Amphenol ICC-CMIO Product Change Notification

Part Numbers Concerned :	U10 Series	Originator:	Jim Hsu
Product Description:	SlimSAS Board mount connector	Issue Date:	2020/7/13
		PCN NO:	P-20-00003
Distribution:	To use laser print to replace Ink print on connector marking

To use laser print on Amphenol SlimSAS board mount connector.

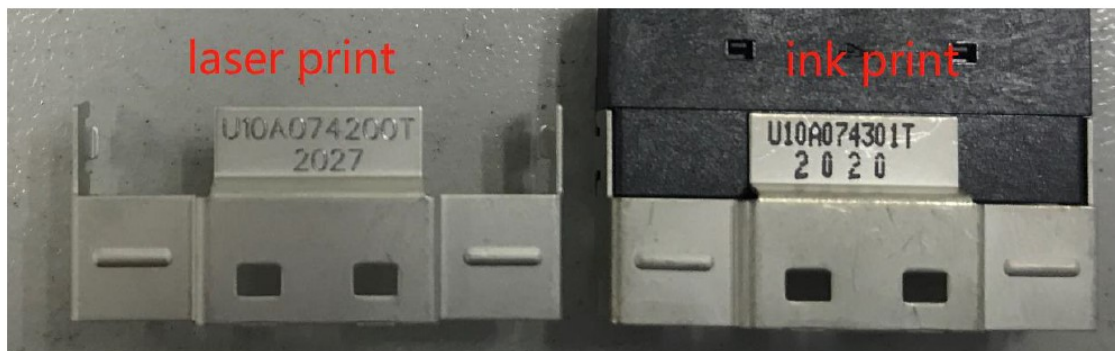
Base on China government's new VOC policy(GB 38507-2020), Ink marking will not be allowed till 2021/4/1, so we would like to implement laser print for marking on our SlimSAS series.
